# Independent Peer Review Panel

## **IPRP Report No. 16**

### **Initial Review of the PG&E “Updated Seismic Assessment, February 2024” by the Independent Peer Review Panel for Seismic Hazard Studies of the Diablo Canyon Nuclear Power Plant**

August 26, 2024

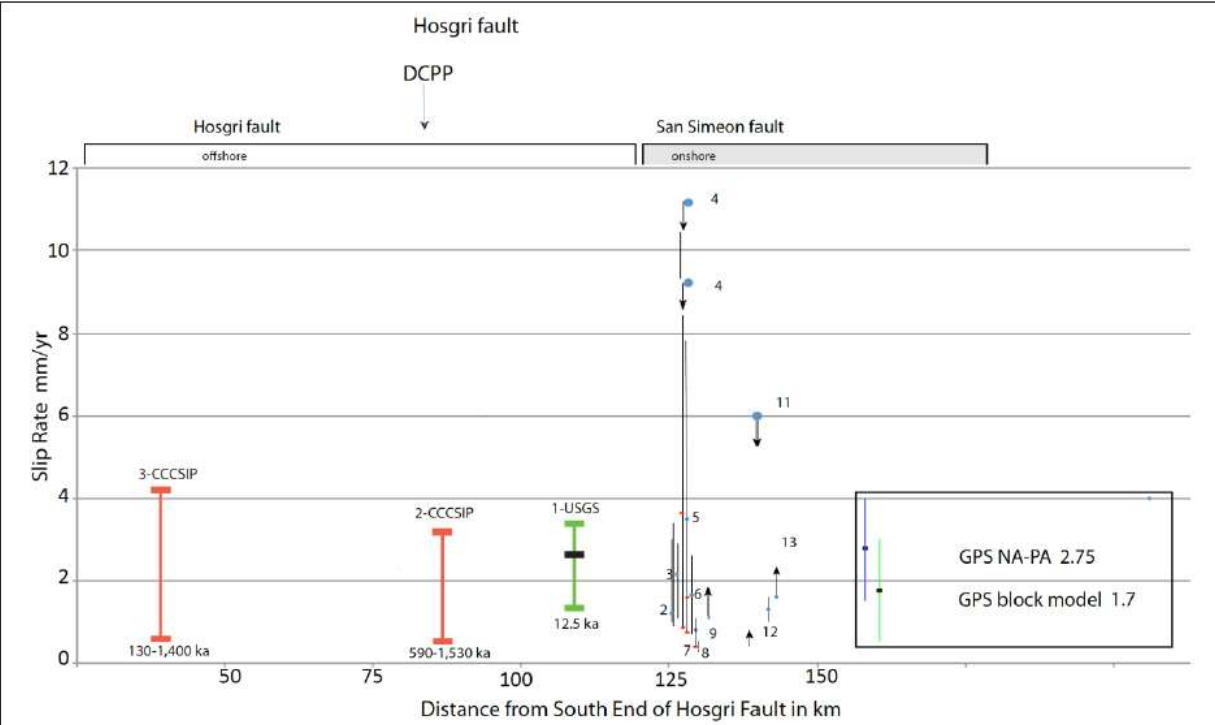
The IPRP considers that these uncertainties, although not perfectly characterized, appear to be captured well by the method used by Johnson et al. (2014). In the 2024 Update, however, PG&E increased the offset measurement range from that reported by Kluesner et al. (2023) by an additional 10 m, concluding: "...the new full uncertainty range (10 to 50 m) also captures the interpreted offsets of the upper slope break and slope face by Johnson et al. (2014)." As all (Johnson et al., 2014, Kluesner et al., 2023, PG&E, 2024) assessments of the CHS agree that the lower slope break is the most reliable offset feature to measure, the modification of values to account for less reliable features does not appear well supported. From the data presented in

Johnson et al. (2014) and Kluesner et al. (2024), their estimates with uncertainties appear justified as-is with no additional modifications.

In Figure 2, we plot the full age ranges obtained at the different slip rate sites. The full age uncertainties could be factored into these rankings, and only the CHS has an age with a relatively low uncertainty. In 2015, when the CHS had no direct age control, the age weighting of the CHS was more defensible. Now, with a fully documented and much more certain age determination, it may be more appropriate to use the age criteria as a screening criterion. Further, if a site is ranked low in age applicability (e.g. Southern Estero Bay and Point Sal), why is it being considered for inclusion at all? In the IPRP report No. 7 (2014), we conducted a thorough review of the offshore sites and concluded their value when compared to the CHS site slip rate was too low to be useful for improving the slip rate used to assess present seismic hazard at the DCP. Now that the CHS site has been improved by additional published studies, diluting the quality of the final weighted slip rate estimate by including less relevant site data is less defensible. We therefore agree with PG&E (5.3.1.2., 2024): "*Due to the more thorough documentation of the CHS age and stratigraphy (Kluesner et al., 2023, Medri et al., 2023), there is greater confidence now than in 2015 that the geological interpretation of the site is correct and that the slip rate estimated from the site is a reliable estimate of slip rate for the Hosgri fault source near the DCP.*"

### Figure 3. Hosgri Fault Slip Rate Calculations from the PG&E Update (2024)

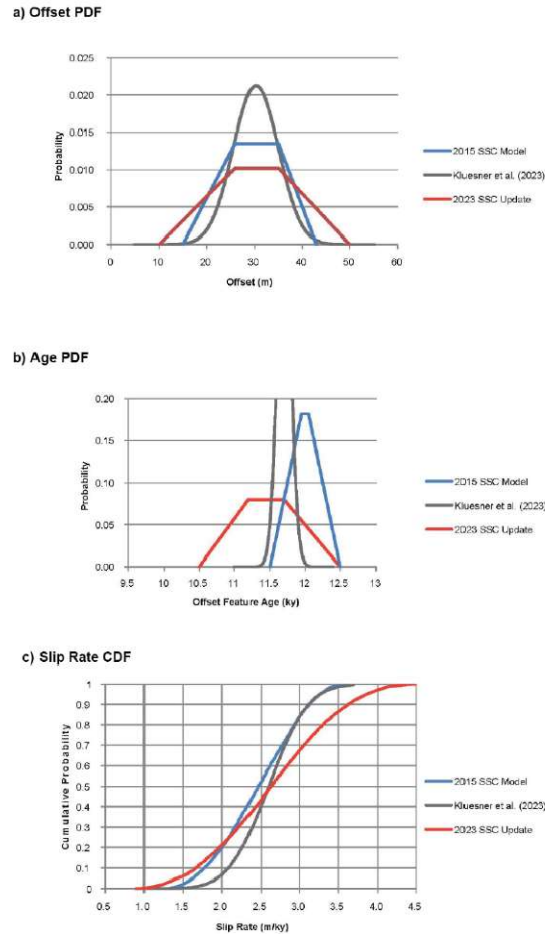
The PG&E Update (2024) recalculated the slip rate of Kluesner et al. (2023) using the input parameters shown in Figure 3. PG&E made changes to the chronology, although these revisions are not documented sufficiently for a full evaluation. PG&E should explain their decisions to broaden the uncertainties and by how much. These changes increased the CHS slip rate from a mean of 2.5 to 2.6 mm/yr. The Kluesner et al. (2023) results are peer-reviewed and well

documented. If PG&E chooses to reinterpret the data and develop an independent slip rate estimate, rather than simply integrate what has been published into the SSC, this should be carefully documented, published formally, and peer-reviewed independently as a new stand-alone model. In particular, the choice of Offset PDF in the 2023 SSC Update for the CHS is a significant departure from the published Kluesner et al. (2023) model and should be further vetted and if pursued should be documented at a peer-review level.

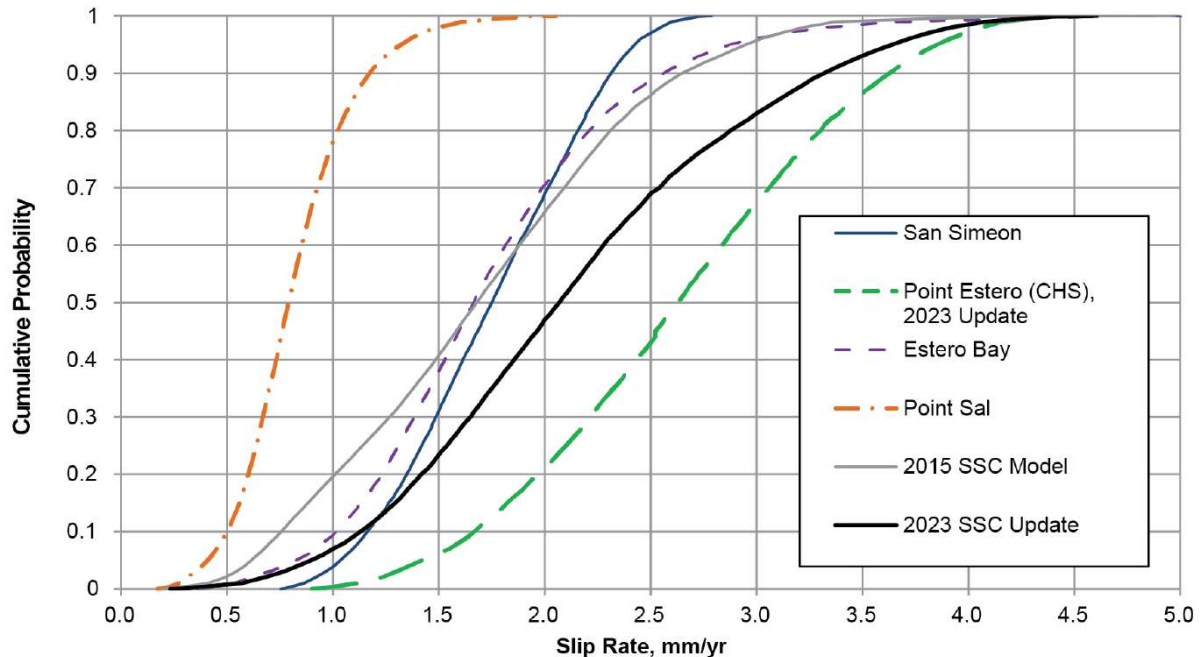
The IPRP recommends using the published CHS slip rate as the Hosgri fault mean slip rate. It falls well within the range of all determinations along the fault (Fig.2) and we agree with PG&E that it is the highest-quality value and most representative of the current hazard at DCP. It is our opinion that the ranking of slip rate sites by *Applicability of Site Location* is not defensible, based on available data and a general lack of supporting evidence that there is a significant change of slip rates along strike of the Hosgri fault between the CHS and DCP. There appears to be evidence that slip rates are accelerating through time based on the modeled slip rates of deformed unconformities by CNWRA, (2016), and PG&E’s own preferred interpretations of the Southern Estero Bay and Point Sal sites. This suggests that older slip rates are not representative of the current seismic hazard, because they are lower than Holocene-age slip rates and thus should not be averaged with high quality data such as the CHS (Kluesner et al., 2023), diluting their effective value (Fig.4). Therefore, it is our opinion that the CHS slip rate of 2.6 mm/yr for the Hosgri fault should receive a weight of 100% in the SSC model, which would result in a doubling of the scale factor from 1.26 to 1.53 as presented in Table 10-1 (PG&E, 2024)

**Figure 5. Map of Faults and Uplifts in the Southwestern Coast Ranges (Fault source: USGS Quaternary Fault and Fold Database).**

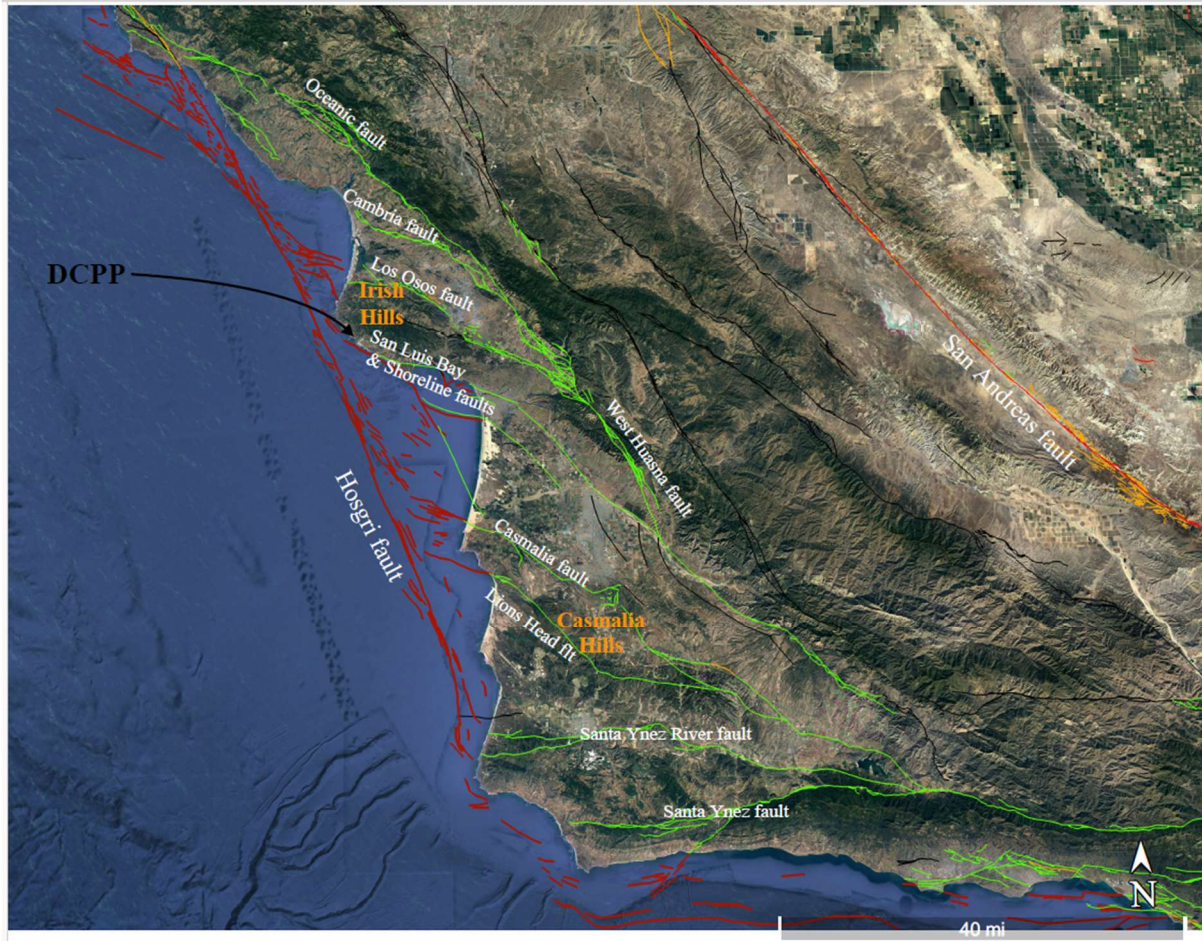
The understanding of the three competing fault geometry models (OV, SV, and NE) remains unchanged from the 2015 report. We still don't know whether the Los Osos fault is a reverse-oblique fault or purely thrust-reverse. We don't know whether the Los Osos fault or San Luis Bay fault is responsible for uplift of the Irish Hills. This unresolved issue of fault geometry highlights the need for improved geologic characterization of the Irish Hills and the bounding faults. Without a single geologic model for the Irish Hills that is clearly supported by hard data, there is greater

(perhaps unrecognized) uncertainty regarding the seismic hazard model. Given that the DCP is located in the Irish Hills, the lack of fundamental understanding of fault geometry and the mechanism responsible for the uplift appears to limit the potential for meaningful seismic hazard analysis.

There are potential options to improve the characterization of the faults that bound the Irish Hills. For instance, offshore seismic reflection profiling has been very successful at determining slip rates for the Hosgri fault and the Shoreline fault. That method could also be used to investigate other faults. Limited offshore seismic reflection profiling by the U.S. Geological Survey indicates that the Los Osos fault is a broad fault zone characterized by local vertical faults and flower structures, indicating strike slip faulting. If this preliminary work can be followed up with more detailed low energy seismic reflection profiling of the offshore Los Osos fault (such as can be accomplished using Chirp or sub-bottom profiler equipment capable of high-resolution imaging extending tens of meters below the ground surface), it may become easier to evaluate the three competing models and identify a single fault geometry model supported by geologic data. It is our opinion that additional geologic investigation along the Los Osos fault and South Boundary faults, both onshore and offshore, is warranted to resolve the fault geometry issue.

**Figure 6. Earthquake epicenters (blue stars) and ground-motion recording station locations (open red triangles) for the supplemental DCP California empirical catalog (from PG&E 2024, Figure 4-2).**

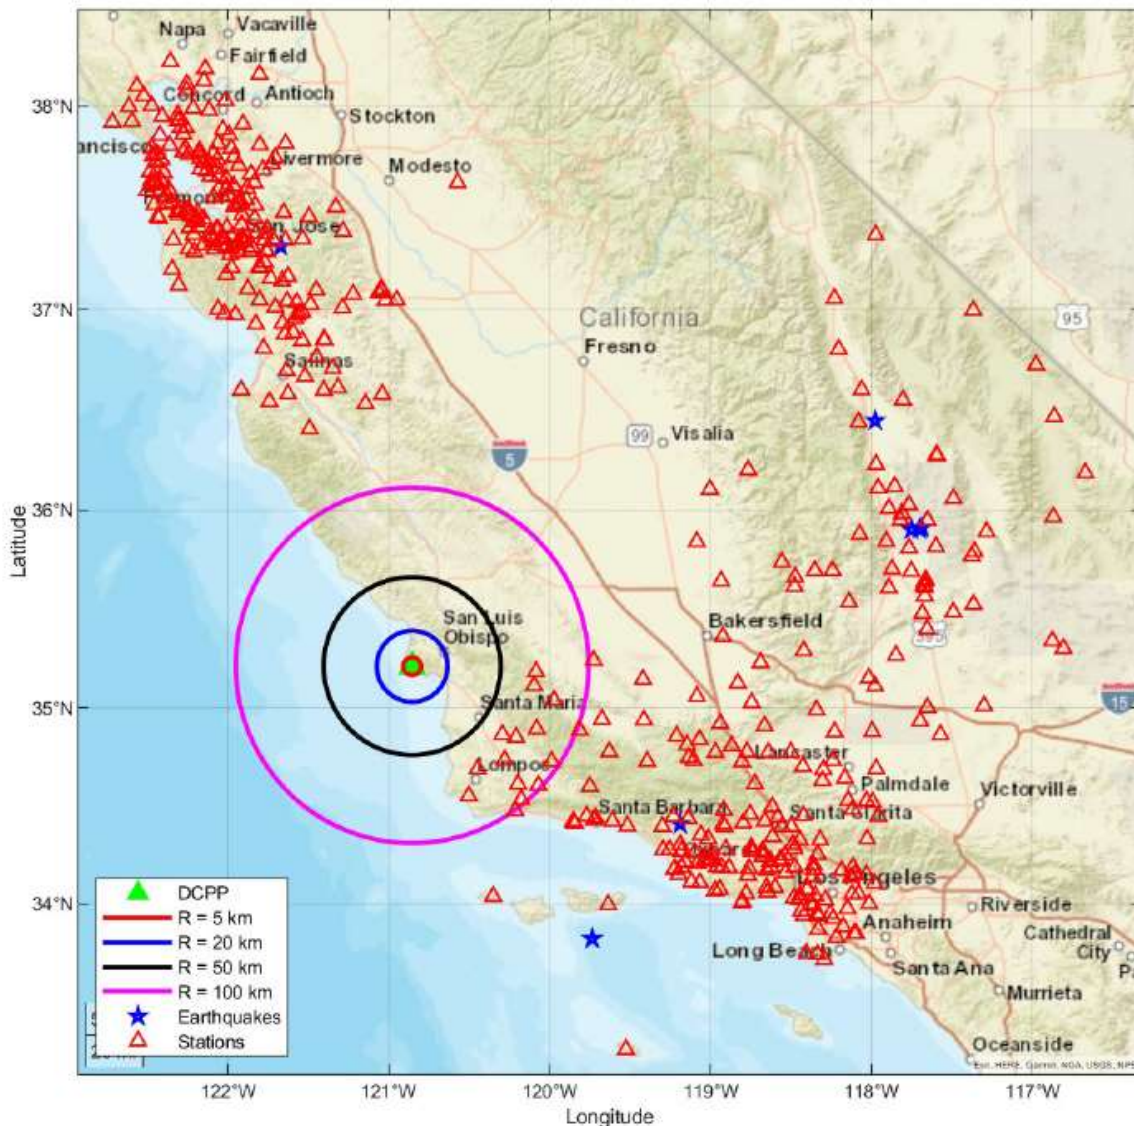
We found PG&E's search and evaluation for new ground motion data complete and agree with their assessment that simulated data are either not new or not appropriate for the DCPD except for informing specific components of ground motion characterization. There are no new ground motion data to refine empirical site term. In fact, there are no new ground motion recordings within 50 km of the DCPD site as shown in Figure 6.

**Figure 9. UHS from the 2015 study (solid lines) and the updated results (dashed lines) for hazard levels of  $10^{-4}$  (blue lines),  $10^{-5}$  (red lines), and  $10^{-6}$  (green lines). (from PG&E 2024, Figure 10-18).**

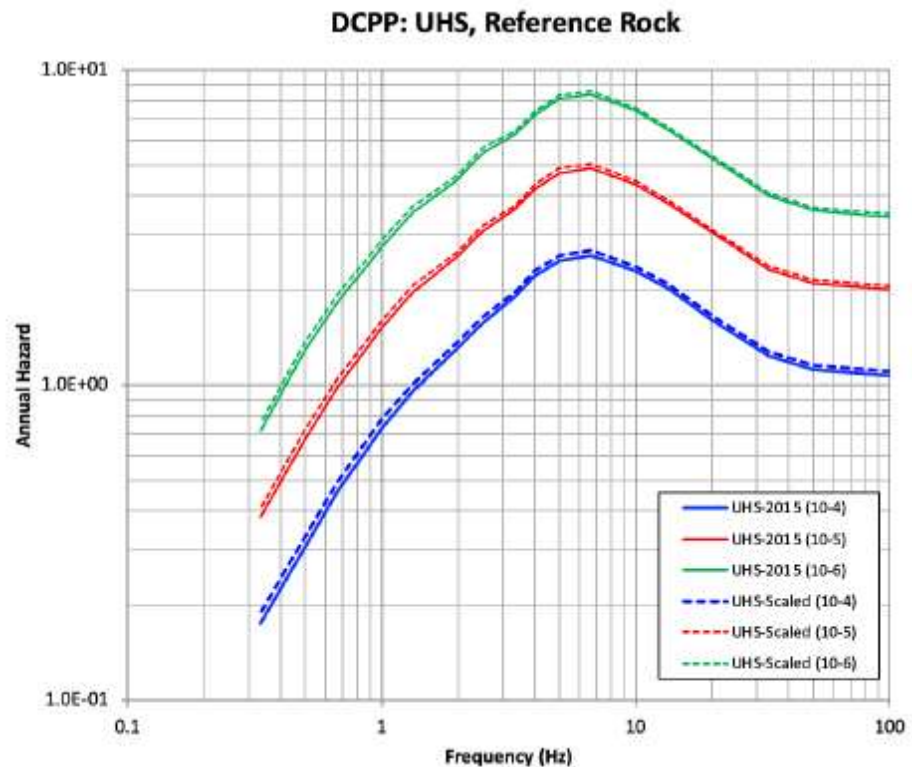
The PG&E scaling approach to incorporate changes in slip rates appears appropriate. The resulting updated hazard curves, uniform hazard spectra (Figure 8), and GMRS (Figure 9) also appear reasonable. It would be good to illustrate mathematically why hazard curves can be scaled by the same factor as the mean slip rate. It would also be good to clearly state any underlying assumptions of this scaling approach and discuss why these assumptions are appropriate. It

**Figure 10. Hazard curve ratio (i.e., scaled hazard divided by 2015 hazard) plotted as a function of 2015 total hazard (solid blue line), scaled total hazard (dashed green line), and selected scale factor (dashed red line) for 5 Hz. (from PG&E 2024, Figure 11-4)**

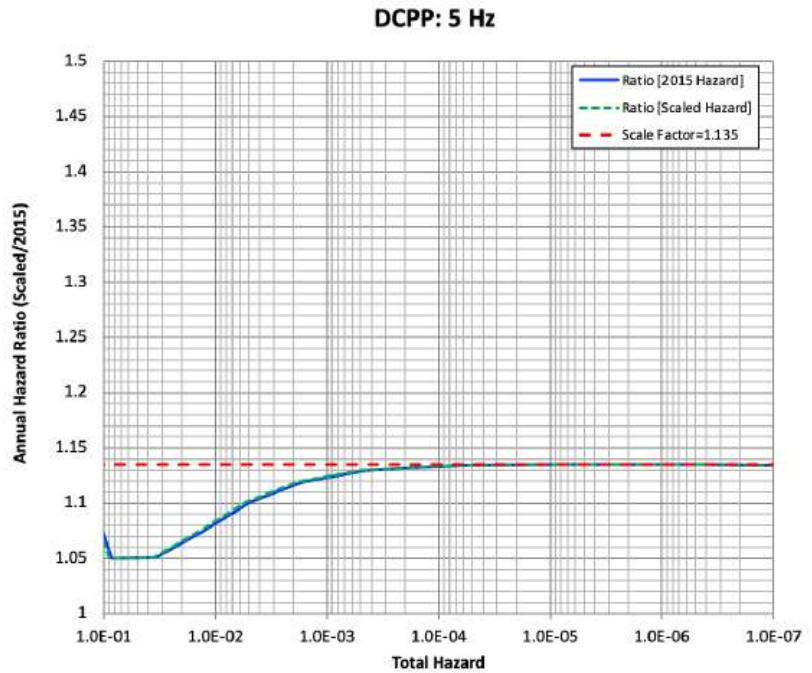
hazard divided by the 2015 hazard varies by hazard level at multiple spectral frequencies. For simplicity, a constant ratio was recommended for a given spectral frequency to approximate scaling factors. The recommended ratio is the ratio at the hazard level near  $10^{-5}$  (Figure 9). The scaling factor is 1.135 for 5-Hz hazard curve which is what PRA study is based on. The highest factor is 1.233, which is based on the 0.5-Hz hazard curve. PG&E recommends using this highest ratio for bounding sensitivity study to be conservative.

The recommended hazard-level independent scaling factors for the control point hazard curves appear reasonable given overall small changes. We agree that the recommended factor of 1.233 for bounding sensitivity study is appropriate for the source models, ground motion models, and site characterization and site adjustment described in PG&E (2024). However, we note hazard results may be subject to revision if the seismic source characterization inputs are modified based on the comments in this report regarding slip rates on the Hosgri fault and models for deformation in the Irish Hills.

**Figure 11. “Tornado Plot” ranking sensitivity of ground motion hazards to uncertainty in input parameters (included in IPRP Report #9, and originally presented by Norm Abrahamson at the January 8, 2015 IPRP public meeting).**

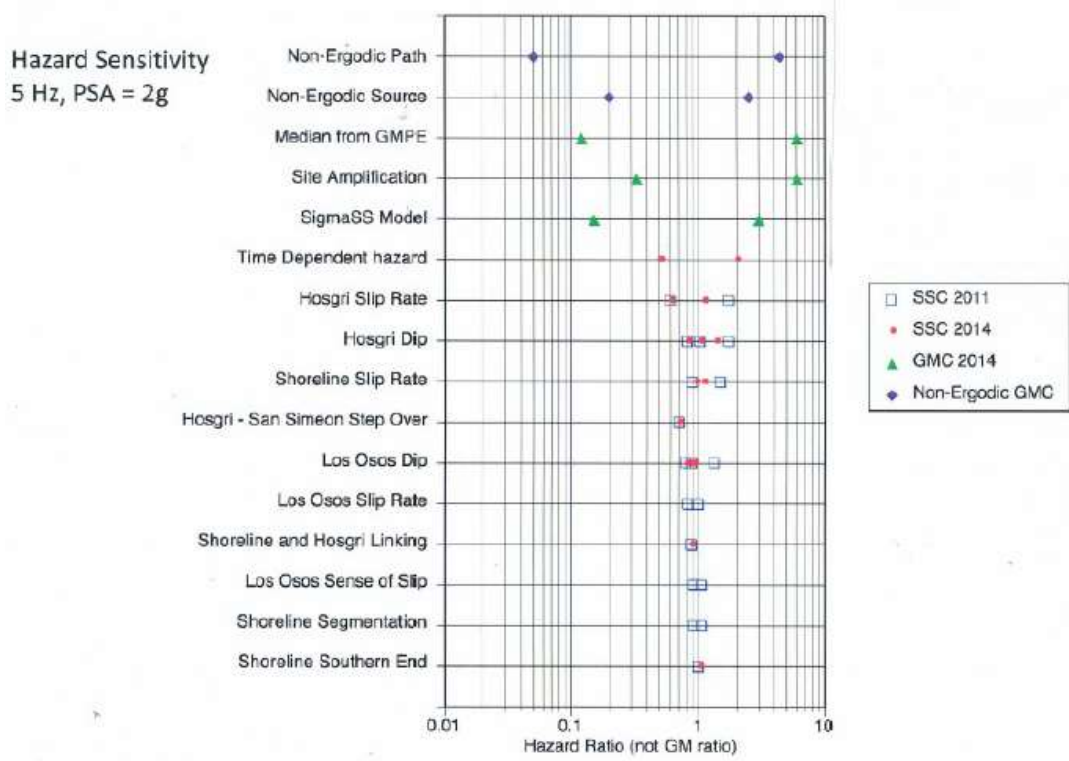
Finally, we reiterate the importance of site characterization, site factors, and ground motion modeling approaches in a site-specific probabilistic seismic hazard assessment. Figure 11 is a tornado plot reproduced from a 2015 PG&E presentation and was cited in IPRP Report No 9 (as Figure 4 in that report). The most striking feature of this tornado plot is the six items related to ground motion calculation on the top of the tornado that have the most uncertainty and hazard sensitivity. We ask PG&E to update the tornado plots as seismic hazards are reevaluated (including for updated fault slip rates discussed in PG&E, 2024), and include the sensitivities of new models as they are developed. These kinds of diagrams help put things in perspective, illustrating the effectiveness of efforts to reduce uncertainty in input parameters, and prioritizing future research.

see an updated sensitivity analysis, typically presented by PG&E in the form of tornado diagrams, ranking ground motion hazards to uncertainties in revised input parameters.
